V8 XJ Series/XK

413-S484

## TECHNICAL BULLETIN

### Instrument Pack Assembly – CAN Failure – Service Action S484

ILLUSTRATION 2

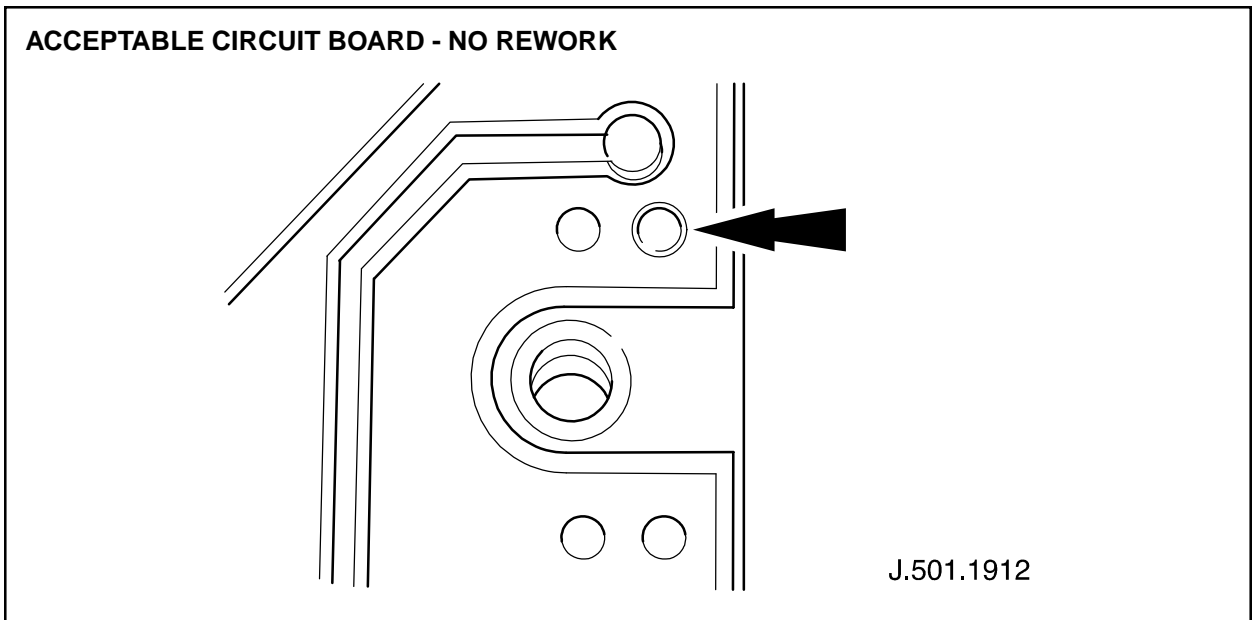
Illustration 2 shows an acceptable circuit board. This board does not require rework.

ILLUSTRATION 3

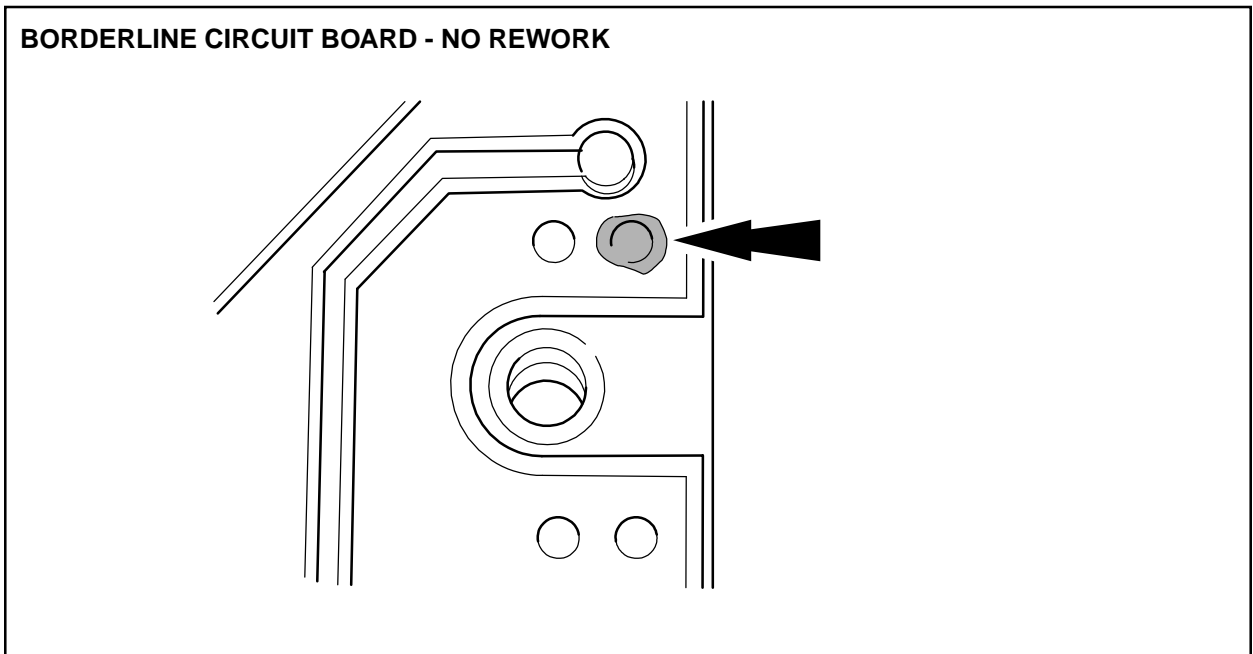
Illustration 3 shows a borderline case. This circuit board does not require rework.

ILLUSTRATION 4

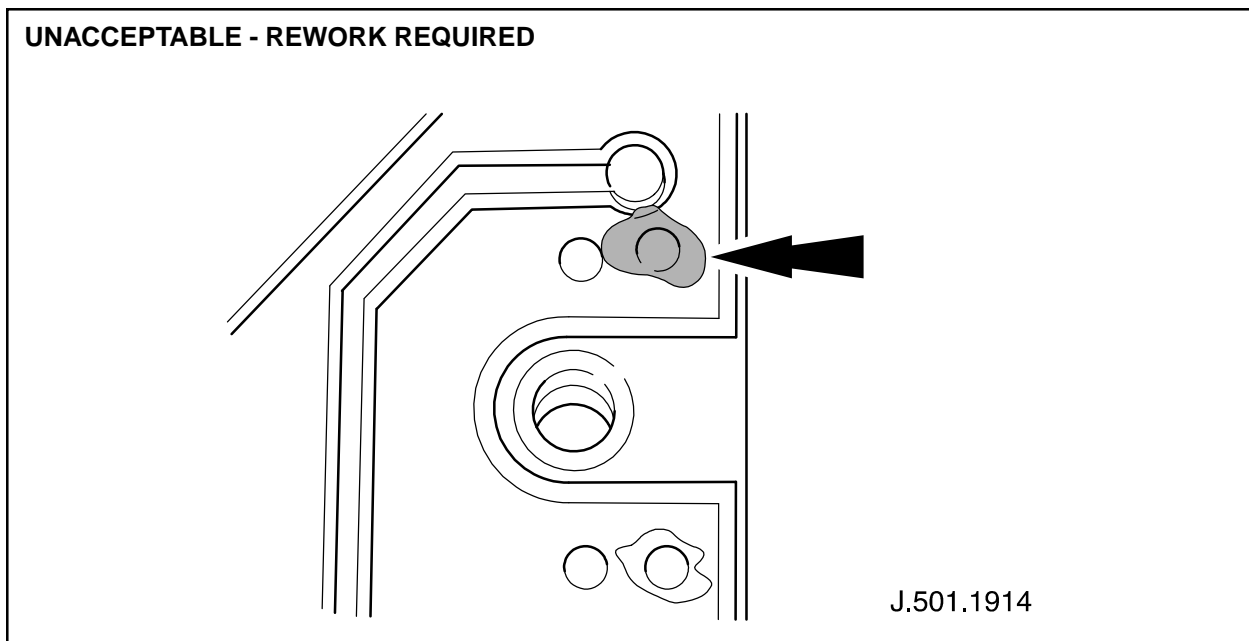
Illustration 4 shows an unacceptable case. This circuit board requires rework

**If rework of the solder area is required (Illustration 4) proceed to step 11.**

ILLUSTRATION 5

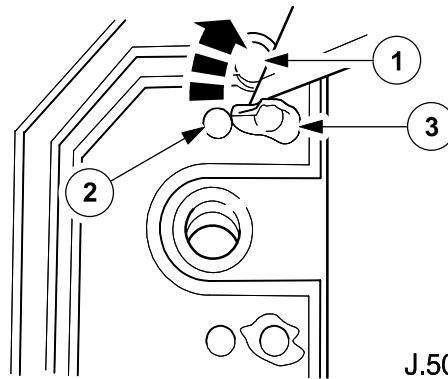
11. Using a sharp craft knife, raise and fold back any solder that has spread beyond the borderline area, as shown in illustration 5
12. Using a sharp craft knife, cut off the raised solder segments. See illustration 5.
13. Using a continuity meter, check there are no shorts between test point 1 and the two adjacent solder points 2 and 3 as shown in Illustration 5.

**Note:** Do not test between points 2 and 3 since these are ground points.

**⚠ Caution:** During the test operation in step 13, if a short is present, repeat solder removal operation.

**⚠ Caution: Do not use the craft knife in a downward cutting action across the board. This will damage the board.** Cut at an angle ensuring that only the solder is cut through. Ensure all traces of cut solder are removed and discarded. Do not leave any solder particles. This could cause further contamination to the board. Do not remove solder from other areas of the circuit board, only those identified in this Service Action.

ILLUSTRATION 6

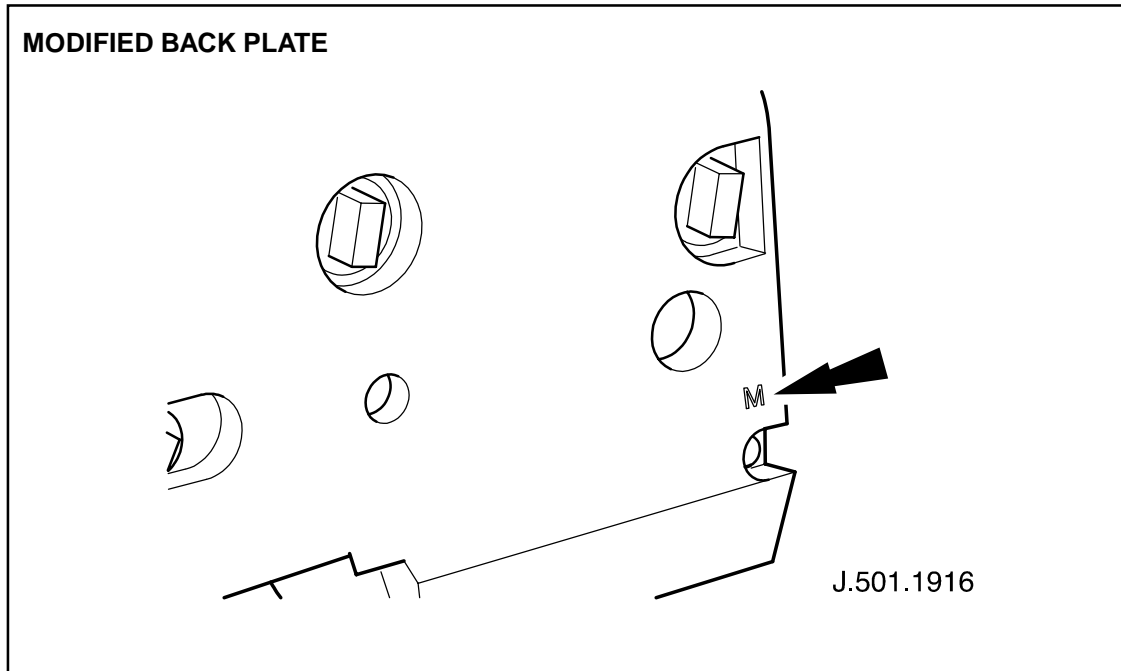
14. Position and seat the new supplied module back plate. (Modified back plate has relieved screw boss).

**Note:** The supplied modified back plate is identified by an “M” mark on the outer face, this will inform future workshops that the back plate has been replaced (Illustration 6).

15. Fit and tighten back plate securing screws. (Torque 0.5 - 0.8 Newton meters)  
Suitable torque screwdriver for previous operation ‘Snap On’ QTSP135 or SPX 18 G.681 & T20 Torx bit.
